DRB FILE: #18-0246
REQUEST FOR MODIFICATION TO DRB FILE: #16-0073
802 W DILIDO RESIDENCE

DRB FINAL SUBMITTAL
APRIL 6, 2018

802 W. DILIDO DRIVE

REQUEST FOR MODIFICATION TO
DRB FILE: #16-0073, TO RAISE
GRADE IN SIDE COURTYARDS
+1'-1" ABOVE ADJ. GRADE

SITEPLAN (PROPOSED)

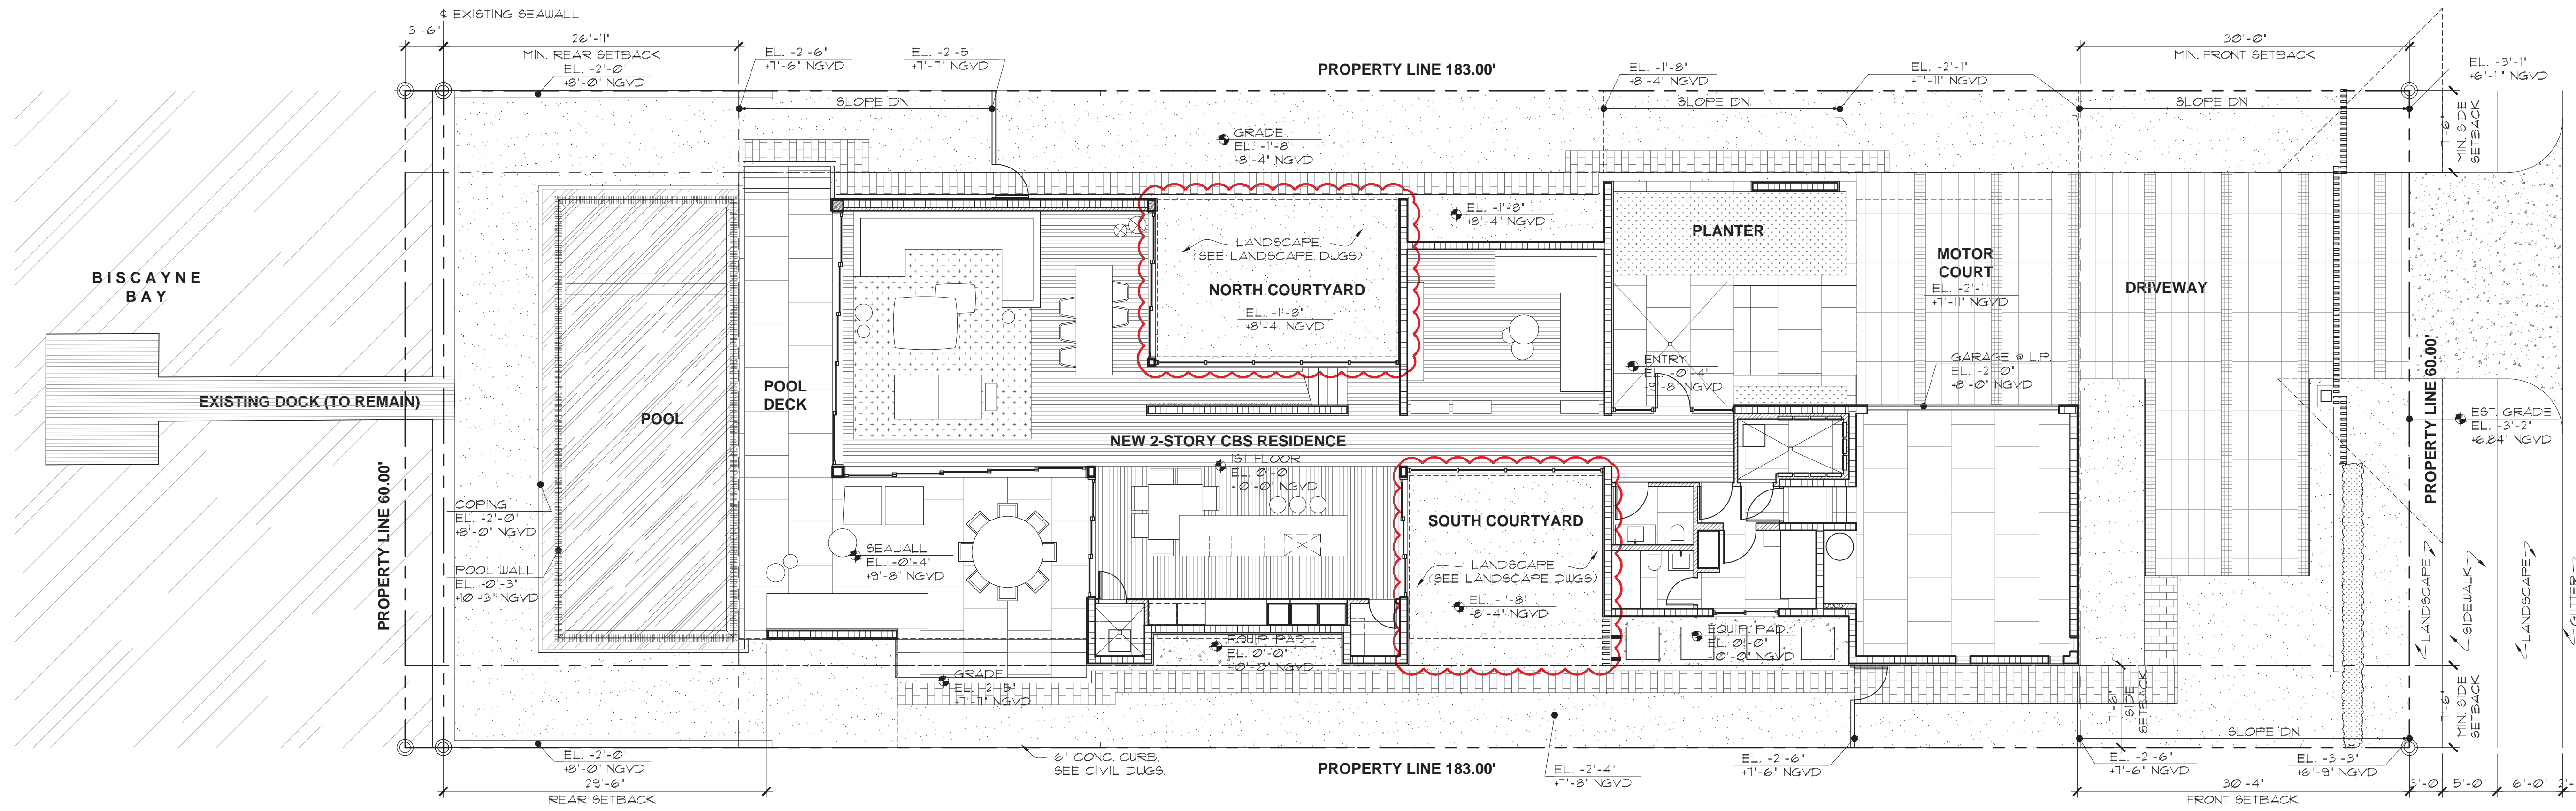
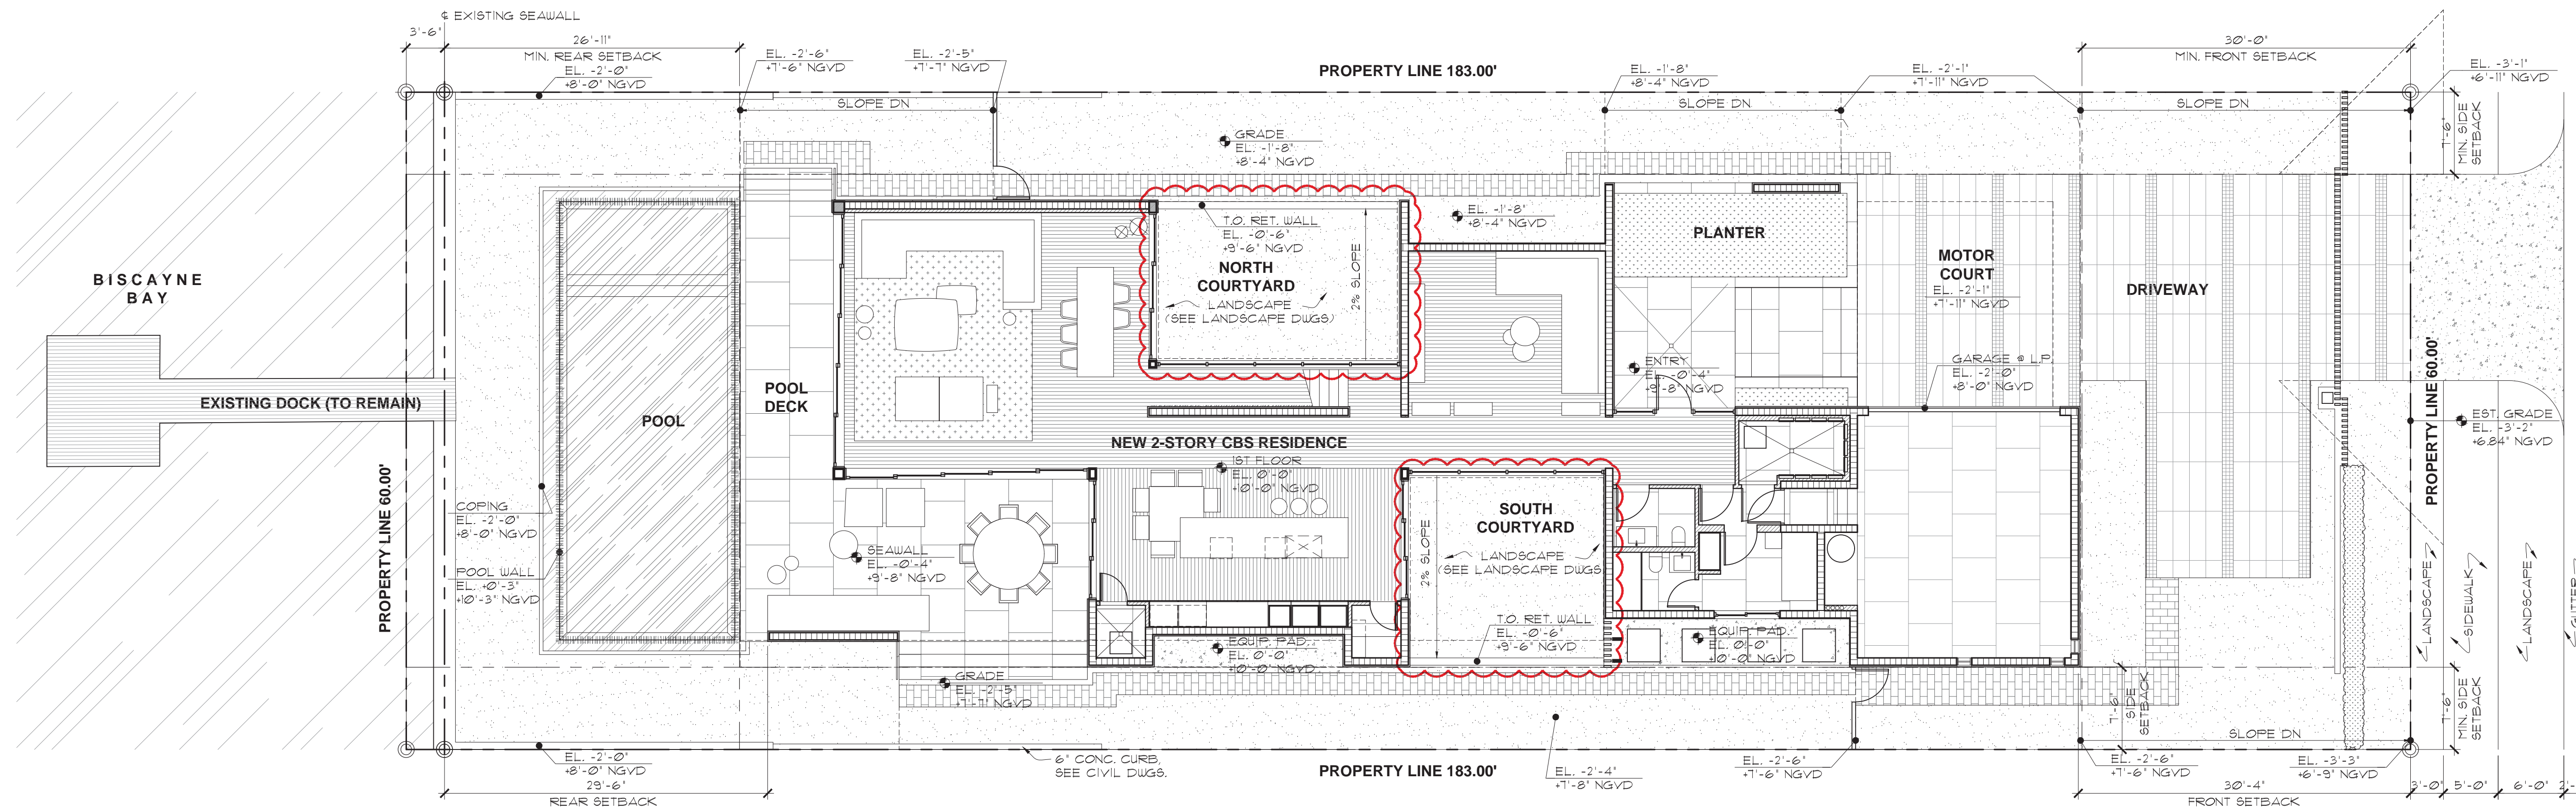
REQUEST FOR MODIFICATION TO
RAISE SIDE COURTYARDS +1'-1"
ABOVE ADJ. GRADE
